**From:** [REDACTED]  
**To:** [REDACTED]  
**Sent:** 2/24/2021 9:16:37 AM  
**Subject:** RE: O8W-PM 35217268, 35224712, 35224713 - Bucks Creek 1101 Phase 1,2&3 - Pre-Engineering Meeting

PM 35217268 (Phase 1)

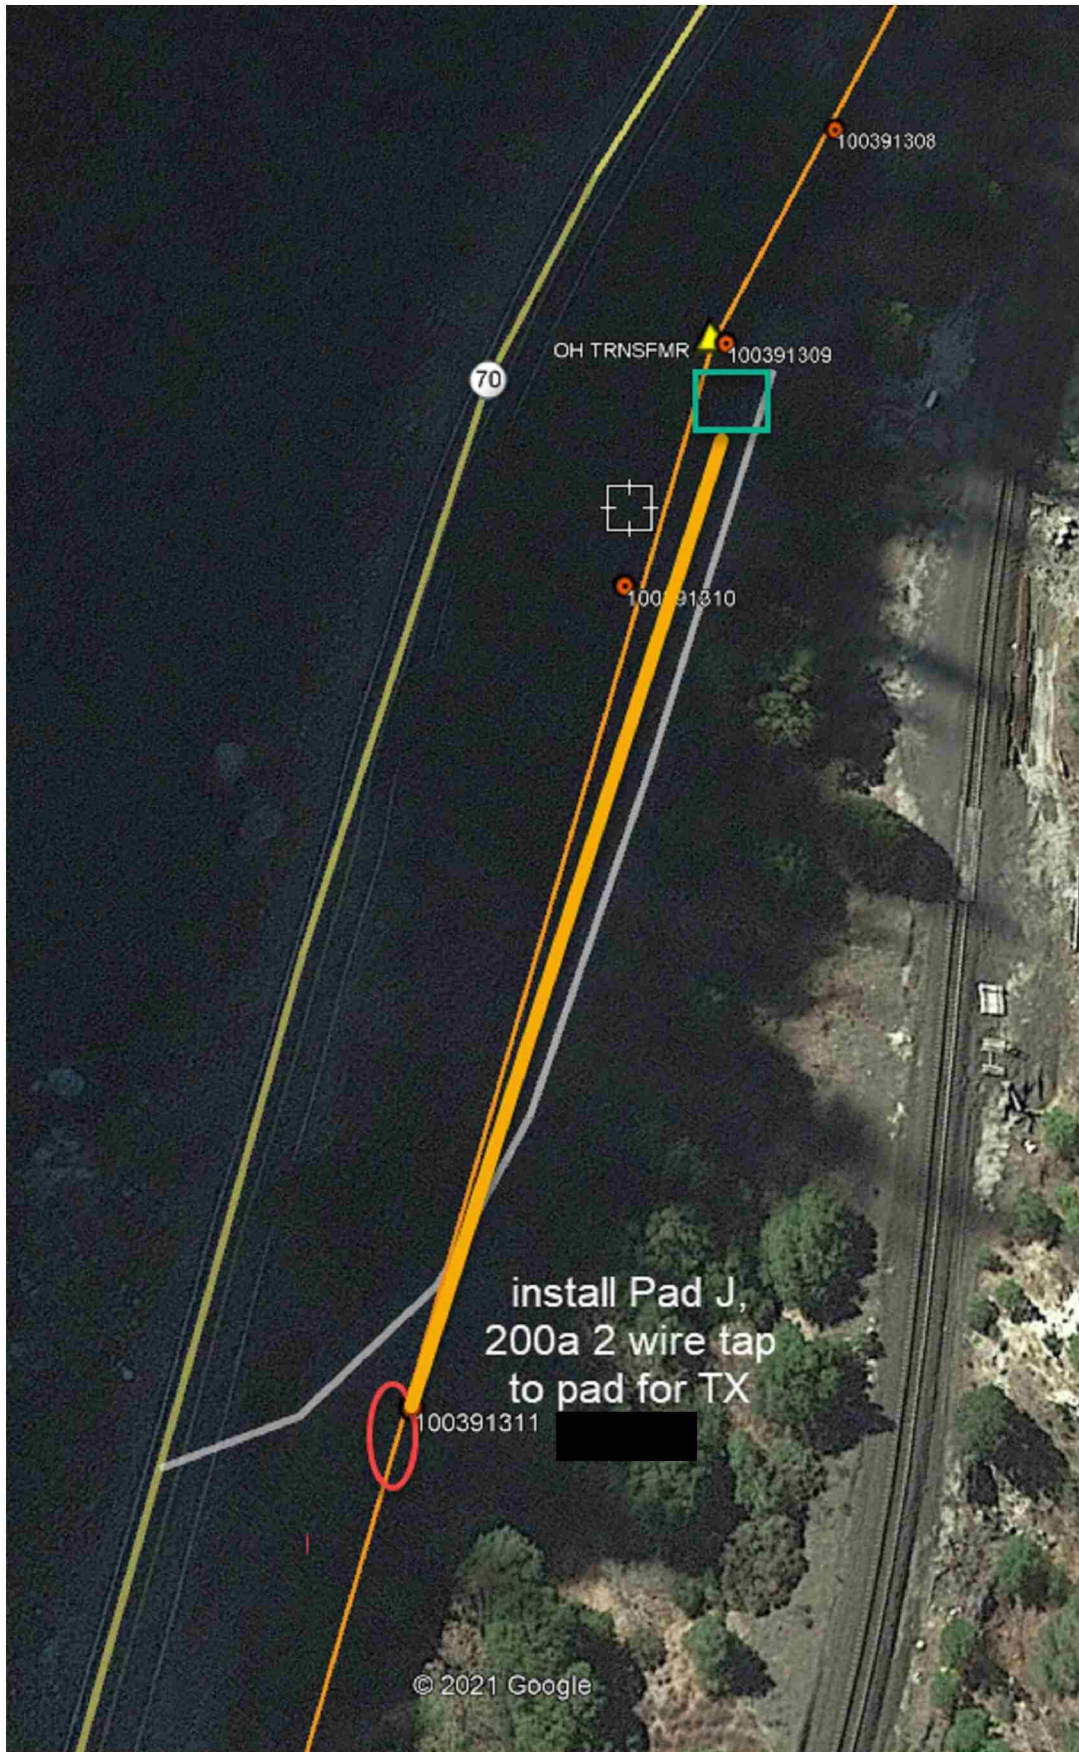
Your outlet red-line Bucks Creek looks close to what I was thinking. Need to work with [REDACTED] to get this designed with a single 6" and use #5 boxes with 200A cable. There is not a reason this will need (2) 6" and 1-4" and 7 boxes. There is probably only 20a peak on the primary now.

Also need to see what Hydro is willing to do with the TX for the penstock metering valve at Rock Creek PH. It will be a long way up from the

Need to see if Hydro has GPR data for the Hwy 70 road bed to see if we can get 42" minimum cover and keep clearance over any hydro facilities.

Merlin can go back like we just did [redacted] Poe. Pad on the Highway and tension secondary 1/0 ASCR across the river. We can negotiate to move the [redacted] service point with my MSA electrician.

the first tunnel window, leave the old TX pole, top it and use to splice in UG service feed.
